# PCN – Product Change Notification

**Document No** PCN-A-110921 **Revision** 1.0

**PCN Topic: Update 15" inches Open Frame Drawing_R15T600-OFA1**

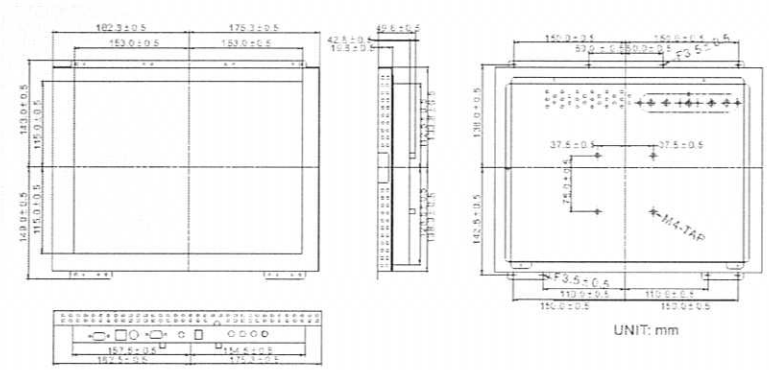
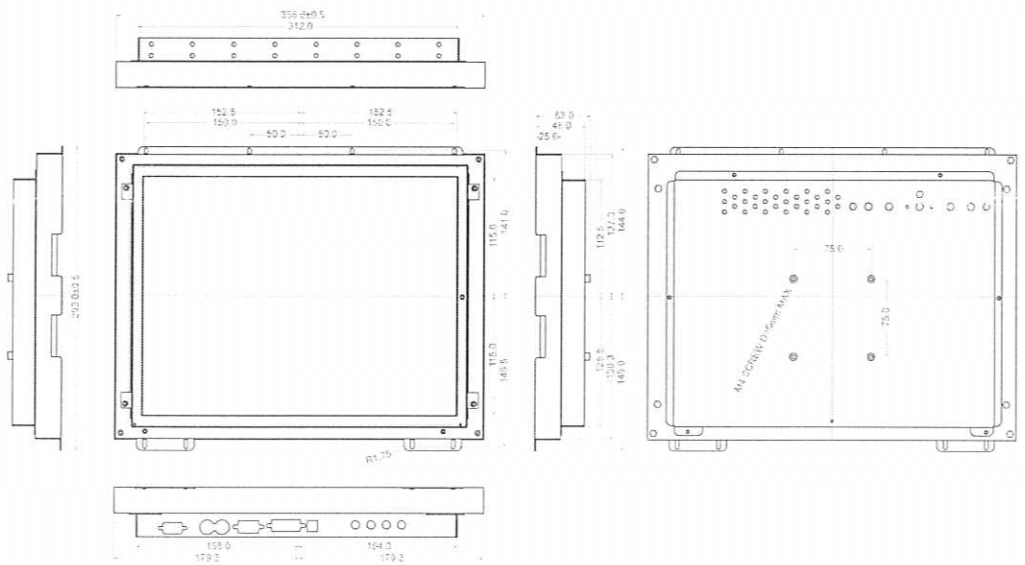
Due to the change of mechanical housing, we would like to inform you that about our Product changes on the product drawing.

We will release new 15" inches Open Frame LCD drawing for the model of R15T600-OFA1,The dimension of this model will be changed from 357.6*292*49.8(W*L*D) to 358*293*53(W*L*D). The below pictures show the example of how the new drawing differ from the original one.
